Wayzata Planning Commission

To: Planning Commission
From: Jeff Thomson, Director of Planning and Building
Date: November 12, 2015
Re: 1120 Wayzata Blvd E Design Review

**1120 Wayzata Blvd E. – David Group Medical Specialty Center
Design Critique (Revised Based on 10/23/2015 Submittals)
November 12, 2015**

C1.1
SHEET 3 of 8

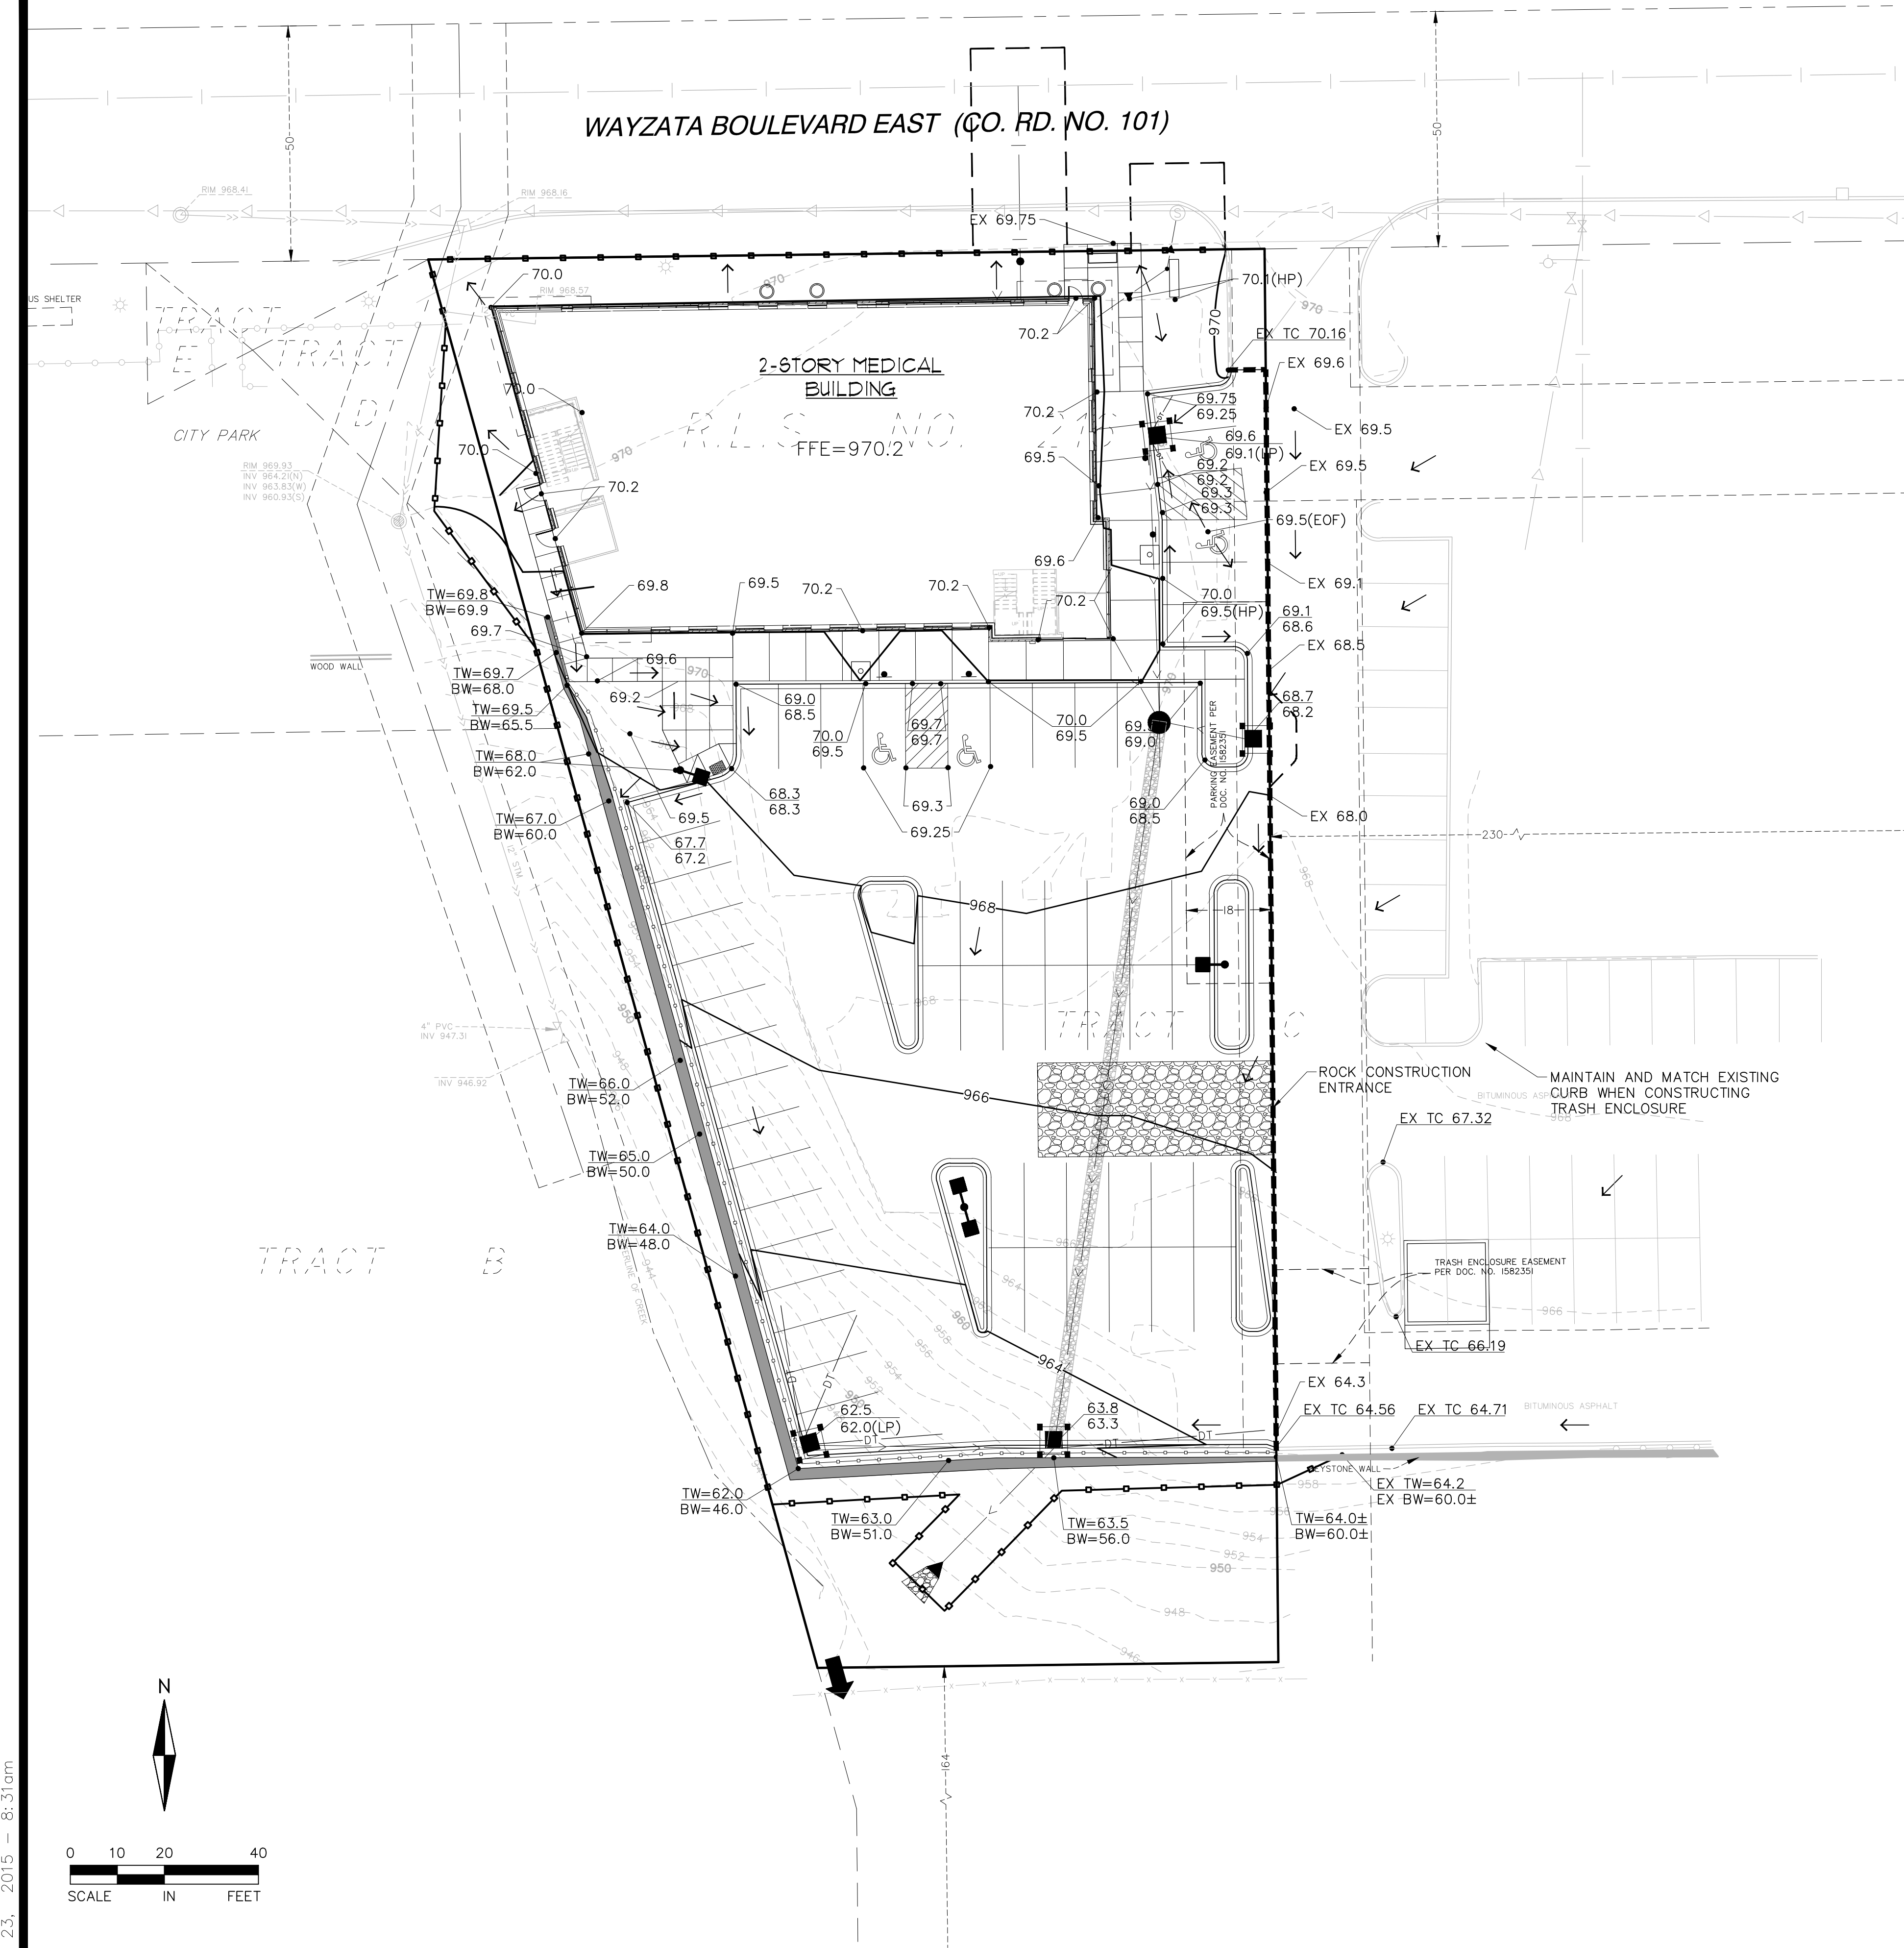
The applicant has submitted a shared parking plan for both properties, as requested by the Planning Commission. The retail building to the east has surplus parking that could be utilized by the proposed development under a cross parking agreement. The retail building to the east currently has 72 parking stalls, but two stalls would be removed for the construction of the shared trash enclosure. The remaining 70 parking stalls is greater than the 52 stalls the site is required to have by the zoning ordinance based on the current occupants. The applicant's narrative states that the adjacent property owner is agreeable to a shared parking agreement, which could be included as a condition of approval. The number of physicians practicing within the clinic would depend on the number of parking stalls included in the cross parking agreement.

- *Shared parking analysis with the 1200 Wayzata Blvd.*
See the attached revised Parking Calculation Plan C1.1 that shows that the total parking requirement for the two properties will be met when combining the parking spaces from both sites. In addition, the revised site plan provides a traffic aisle leading from the entrance off of Wayzata Boulevard to the south end of the site to facilitate bank drive through traffic and improve overall traffic circulation within the site. This is a modification that was requested by the Planning Commission and staff.

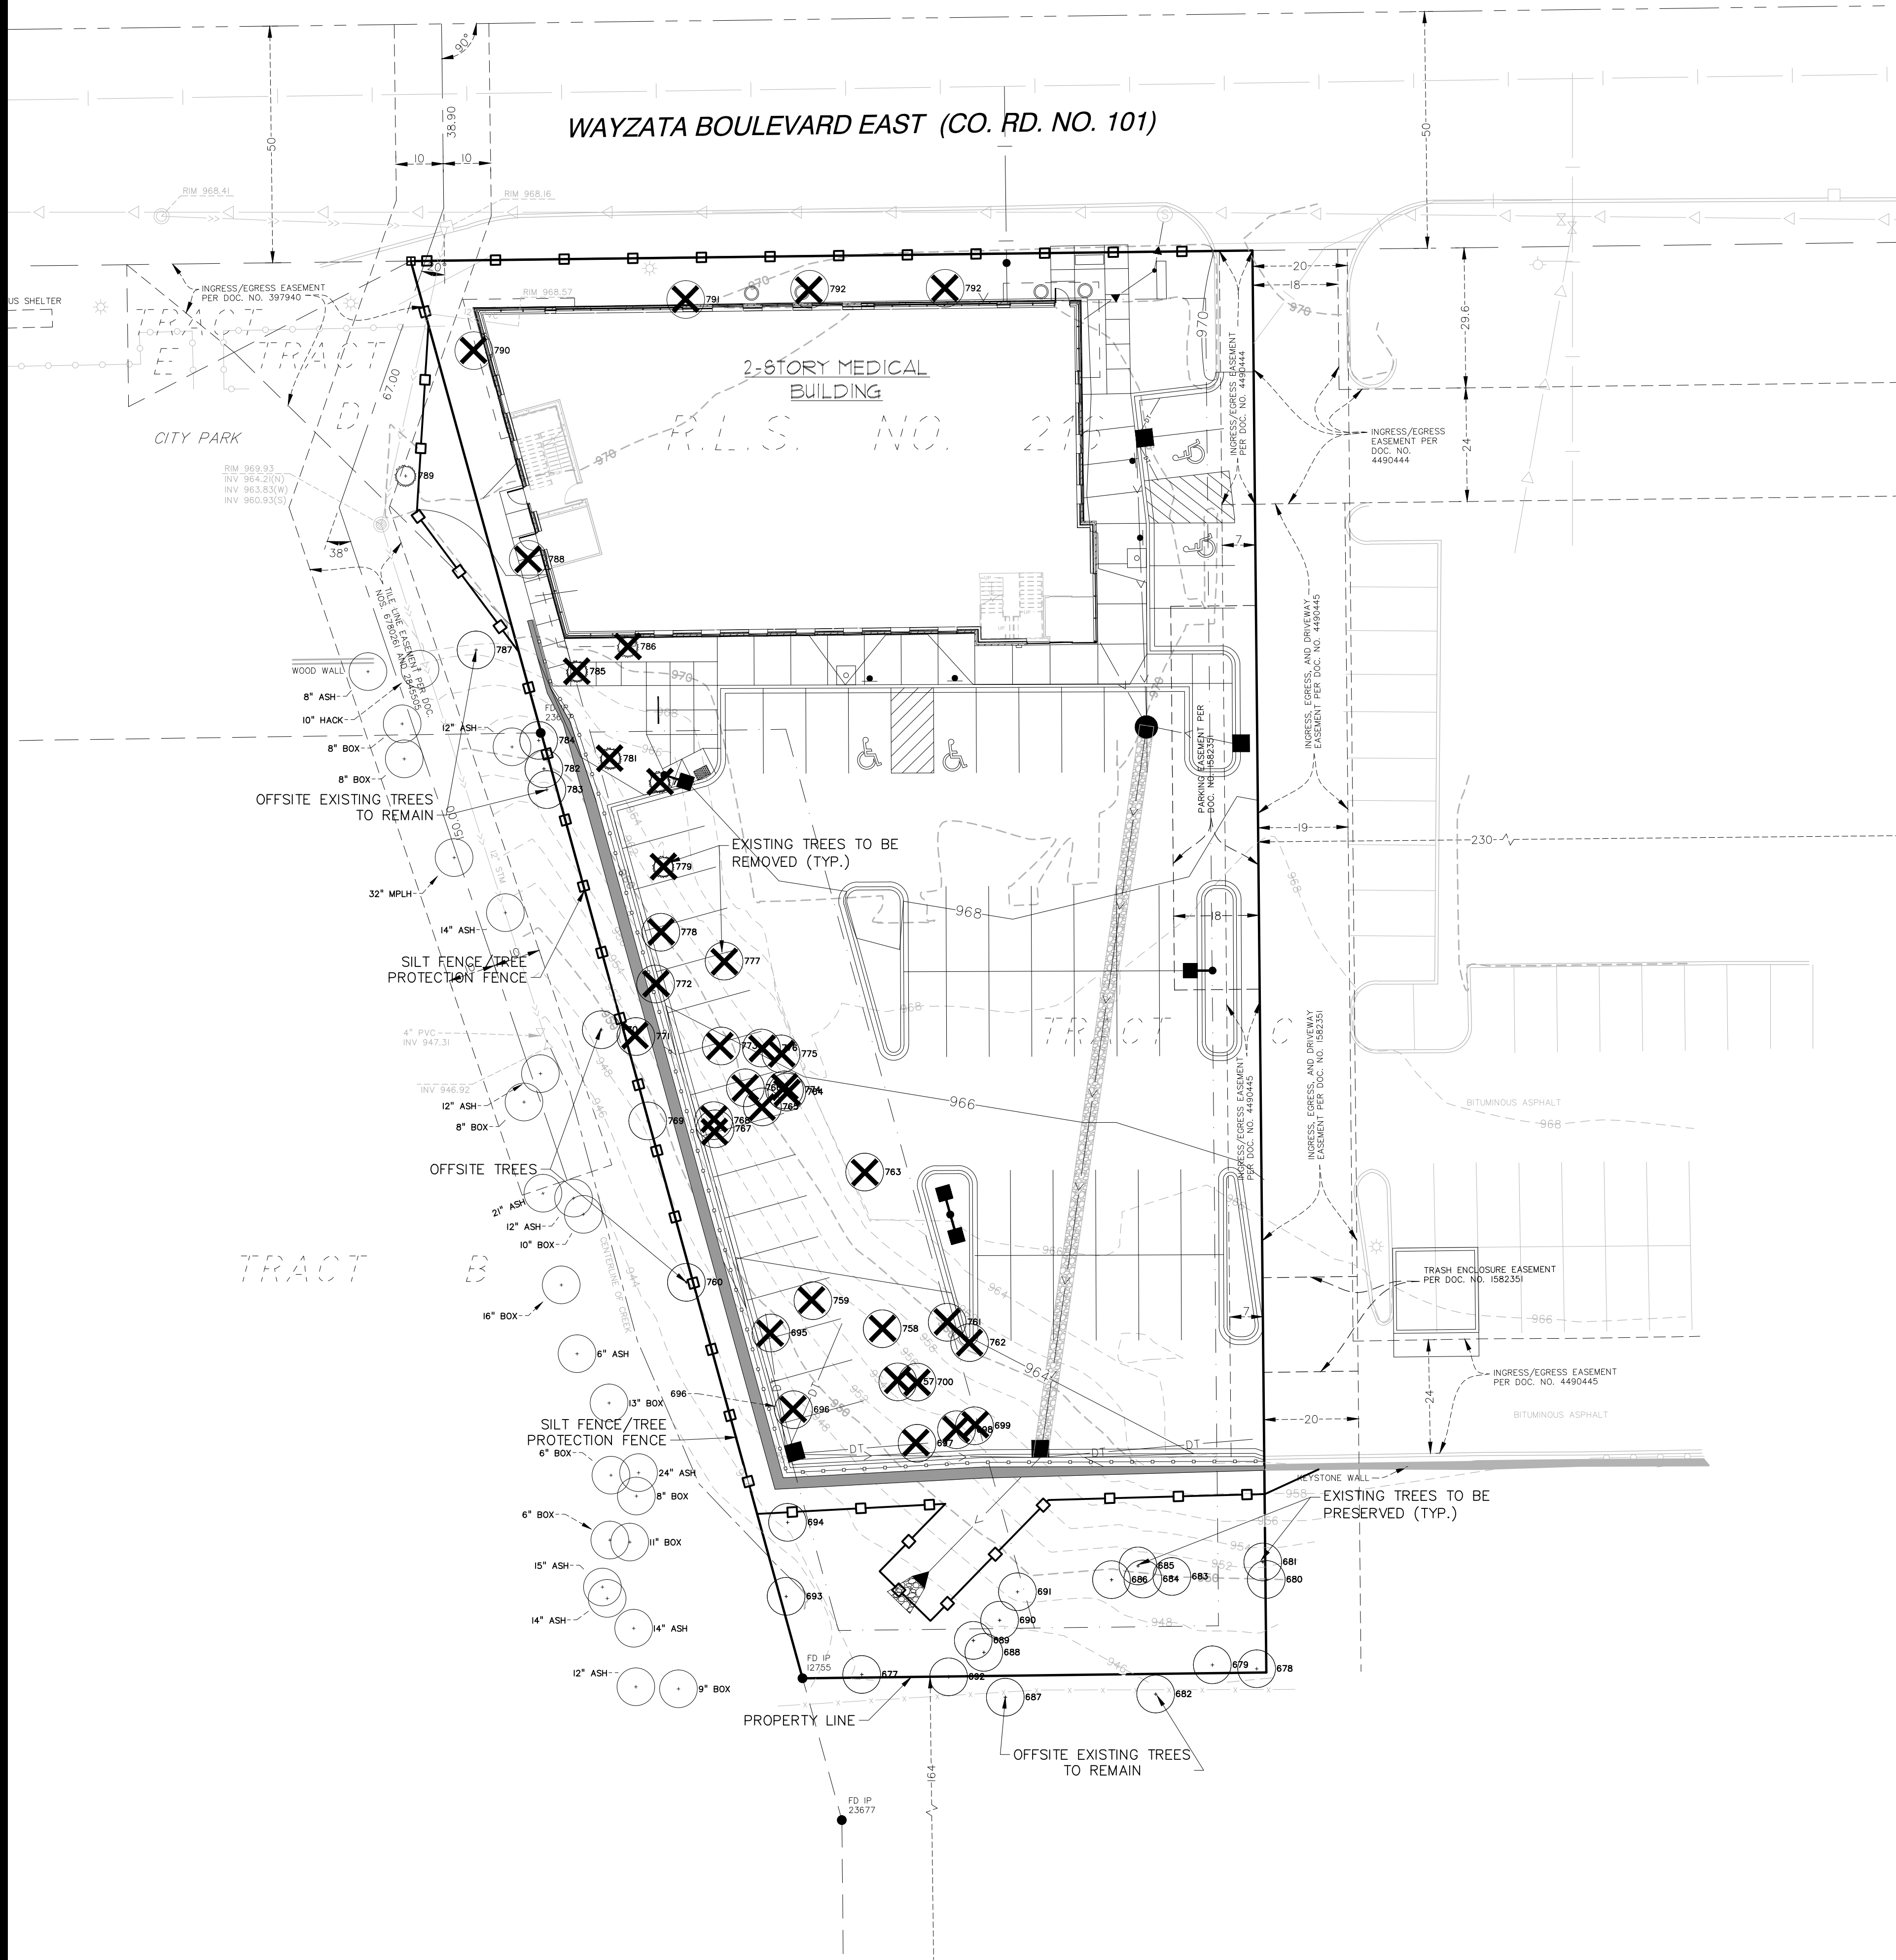
<u>801.09.14.3 – Bluff and Wayzata Blvd Districts</u> Trees with a minimum of three (3) caliper inches shall be planted no more than twenty-six (26) feet apart within a landscaped boulevard.	The Applicant is proposing to install 1.5-inch japanese tree lilacs. As a condition of approval, the Japanese tree lilacs must be substituted with three (3) caliper inch deciduous trees.	Yes

- **Boulevard Trees:** The applicant is proposing three 1.5-inch Japanese tree lilacs along the front of the building for the boulevard landscaping. The design standards (§801.09.14.1 D. and §801.09.14.3) state that trees with a minimum of three caliper inches shall be planted no more than 26 feet apart within a landscaped boulevard. The proposed trees would meet the spacing requirement, but the trees are undersized from what is required by the design standards.

- Boulevard Trees: The Applicant stated that they are willing to provide three (3) inch deciduous trees along Wayzata Boulevard, in lieu of the 1.5-inch Japanese tree lilacs shown on the plans. This is included as condition of approval in the Planning Commission Report and Recommendation.

1 EXTERIOR ELEVATION NORTH (WAYZATA BOULEVARD)
PZ-2 1/8" = 1'-0"

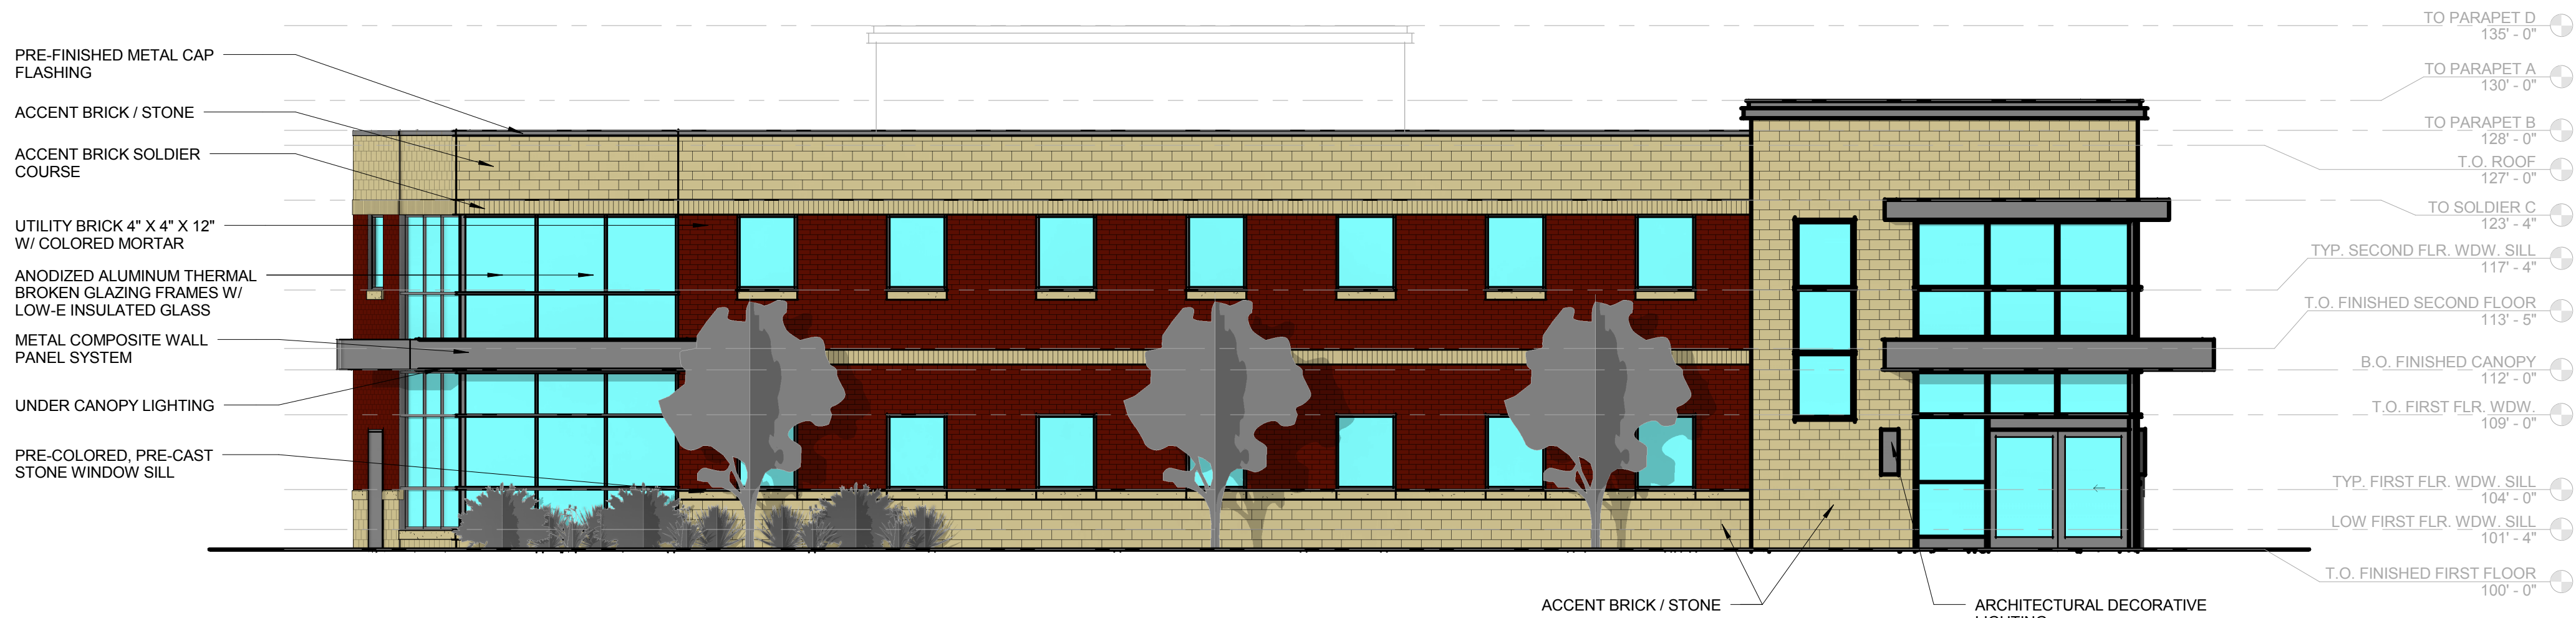
- **Building Entrance:** The building design locates the main entry on the south side, or back of the building, facing the parking lot. There is a door onto Wayzata Boulevard on the northeast corner of the building, but the internal floor plan does not indicate that this would be a main entry to the building. The design standard (§801.09.10.1) states that “main entries” shall face the primary street at sidewalk grade.

Staff Recommendation: City Staff recommends that the north entrance to the building be made more formal by providing a comparable design to what is provided on the south side of the building, such as providing double doors. Additionally, the accent brick material could be added to the corners of the first floor elevation to mimic the design element at the center of the building, and provide a more congruent design across the entire first floor street frontage.

- Main entrance on Wayzata Boulevard E: The Applicant stated at the November 2nd meeting that they are willing to provide a double door entrance on the north side of the building along Wayzata Boulevard. This is included as condition of approval in the Planning Commission Report and Recommendation.
